Highland Estates 24 in. Oversize Approach Water Main (12 in. Required)

Job No.: 14-1178

ADDENDUM 3

July 14, 2016

SHEET **2**
 OF 13

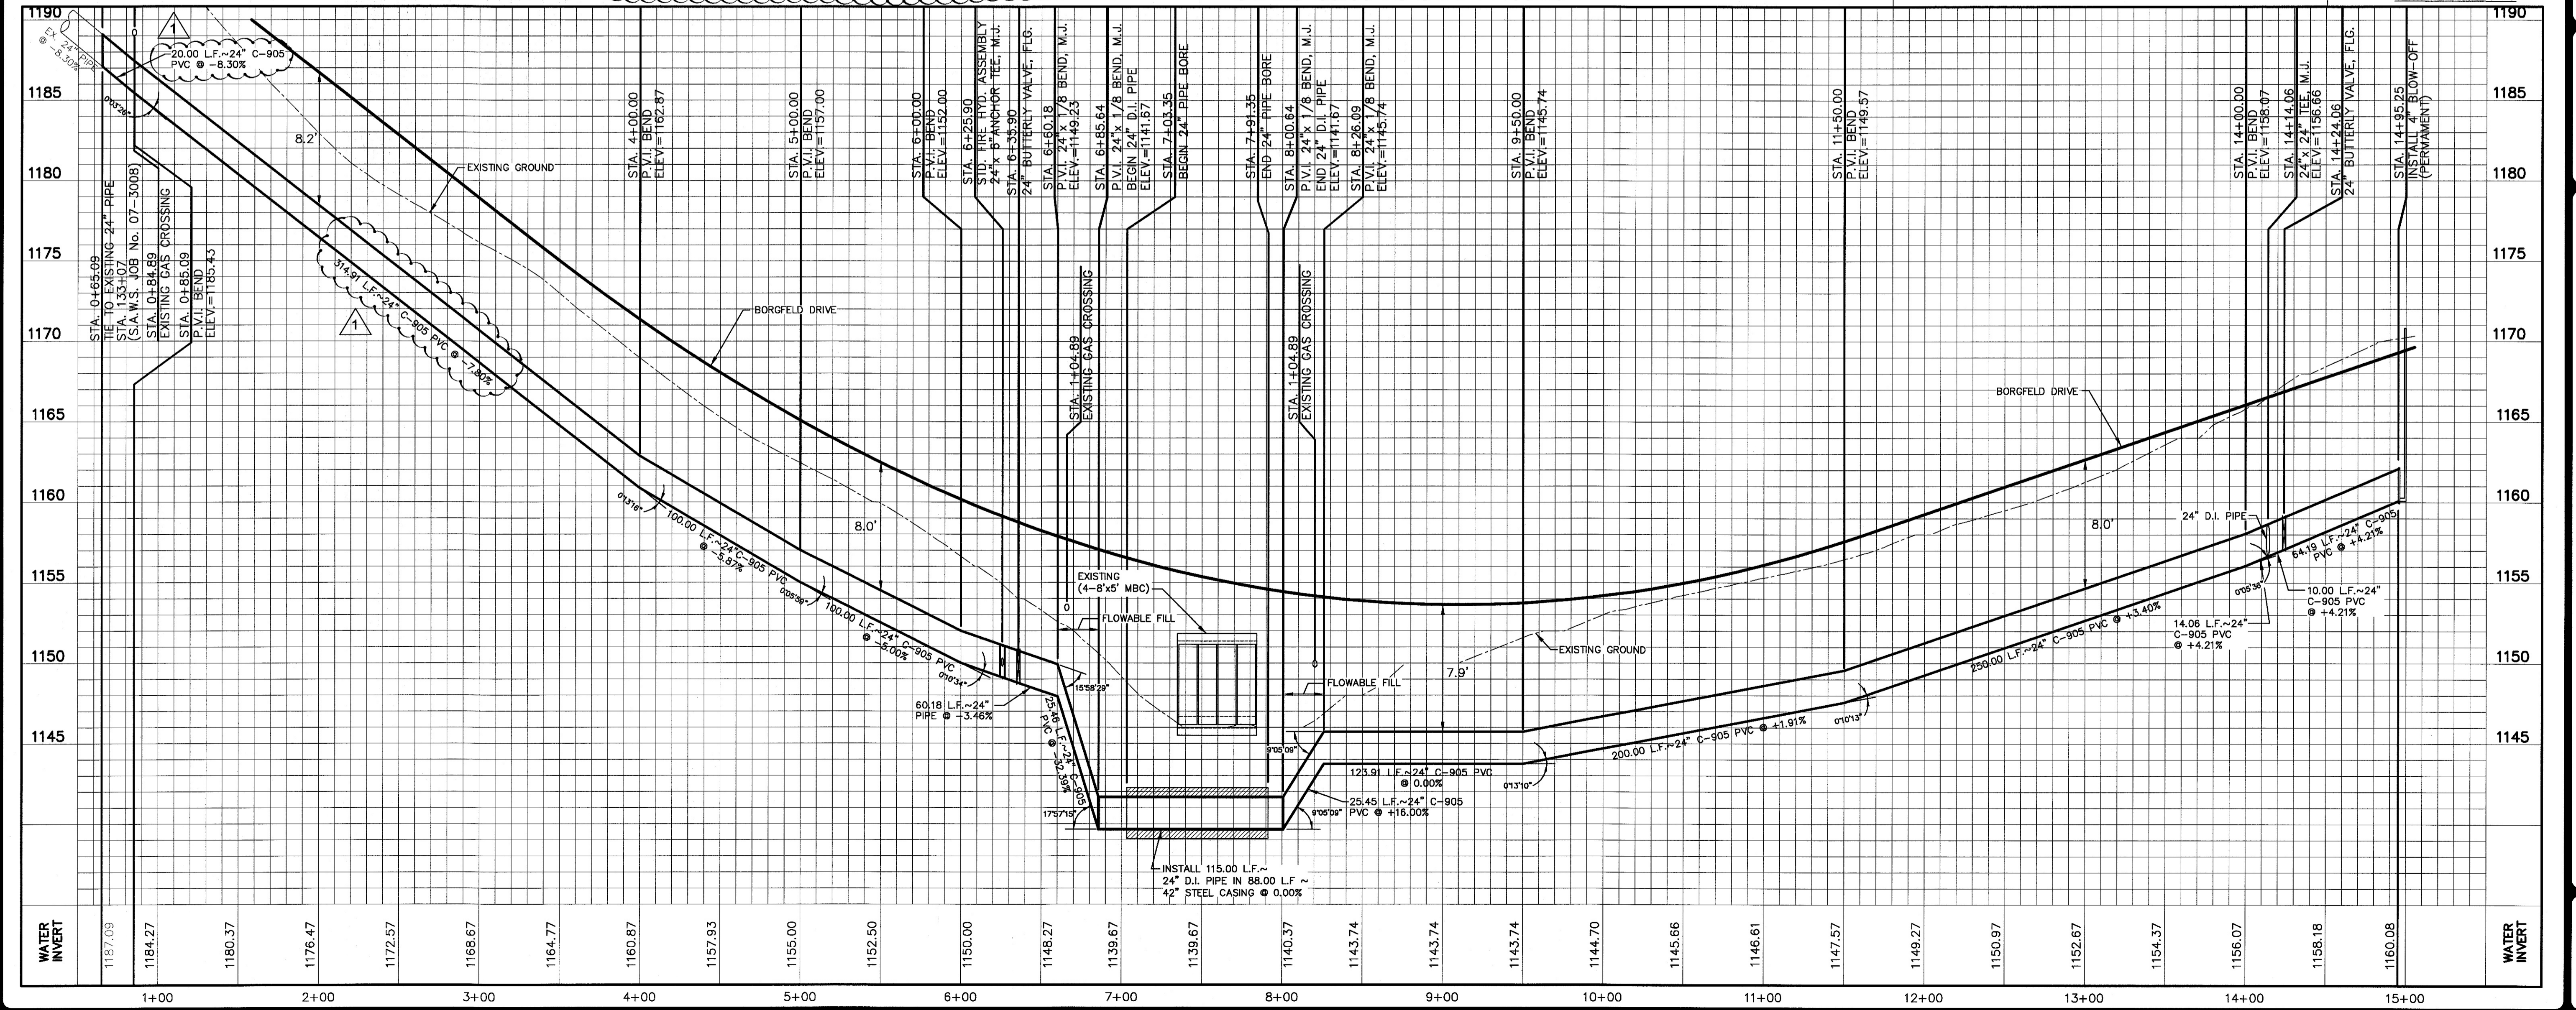
1. Sheet 2, remove from construction set and replace with the attached drawing.

The 24" water line tie-in to the existing 16" water line was shifted to the west by approximately 20 feet.
